**JACKSON OFFICE
WAREHOUSE BUILDINGS A&B**
8140 SANDY COURT
COLORADO SPRINGS, COLORADO 80915

**EXTERIOR
ELEVATIONS**
SCALE: AS NOTED
Sheet Number:
A4
OF 1 SHEETS

**JACKSON VEHICLE
STORAGE BUILDING 'C'**
8140 SANDY COURT
COLORADO SPRINGS, COLORADO 80915

**EXTERIOR
ELEVATIONS**
SCALE: AS NOTED
Sheet Number:
A4.1
OF 2 SHEETS

WEST ELEVATION

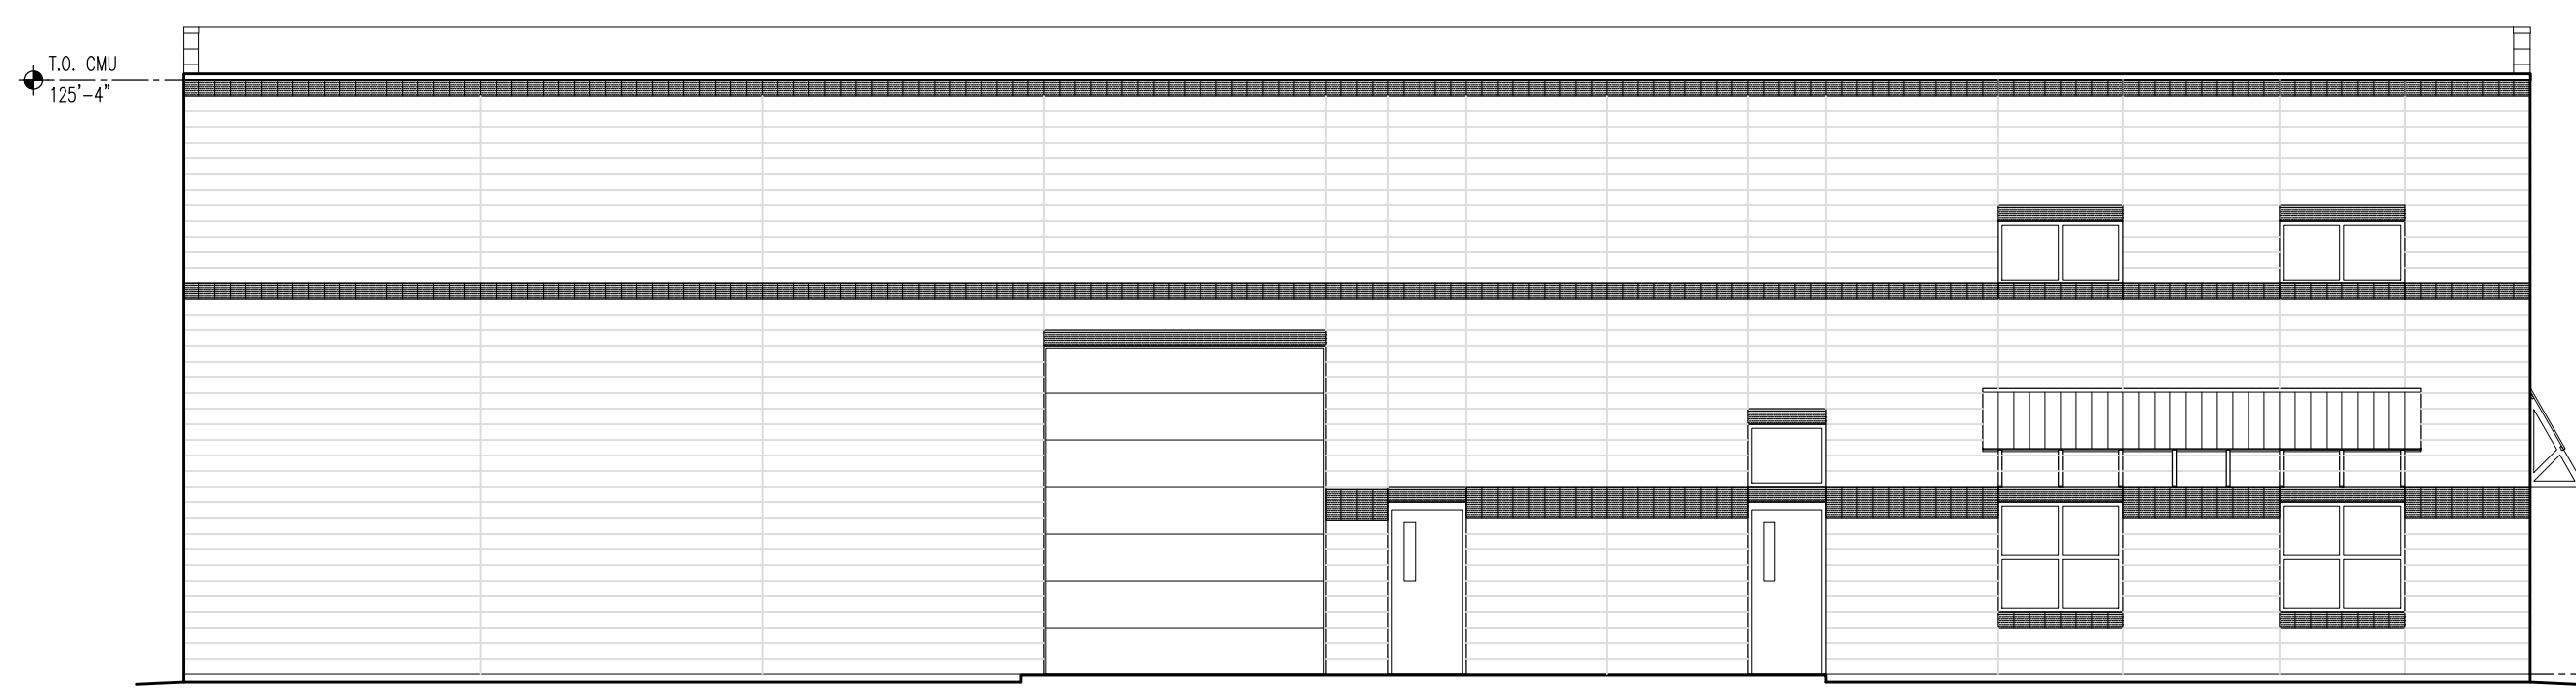
Show height of the buildings, 45' max

Show height of the buildings, 45' max
